Subject: Improvements to C106 PEFS Bracket

Product: 128738 Bracket PEFS C106

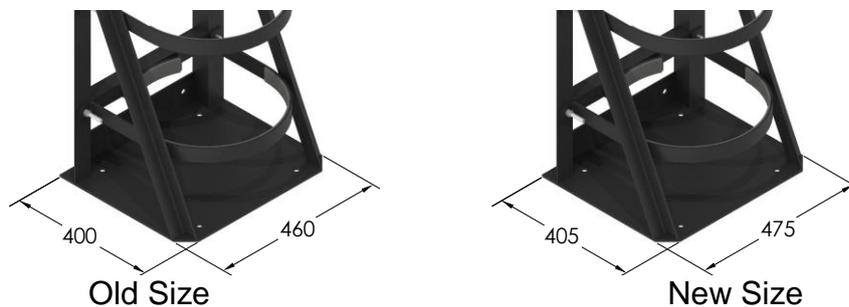
1. Upright Angles:
 - a. Steel grade changed from standard structural grade to high strength structural grade
 - b. Steel angle size increased from 40x40x5mm to 50x50x5mm
2. Brace Angles:
 - a. Steel grade changed from standard structural grade to high strength structural grade
 - b. Steel angle size increased from 30x30x4mm to 40x40x4mm

To accommodate the above improvements the size of the base plate increased slightly as per below figure.

NO CHANGES have been made to any of the mounting hole locations. The improved bracket can be used to replace an old bracket providing there is adequate clearance for the base plate.
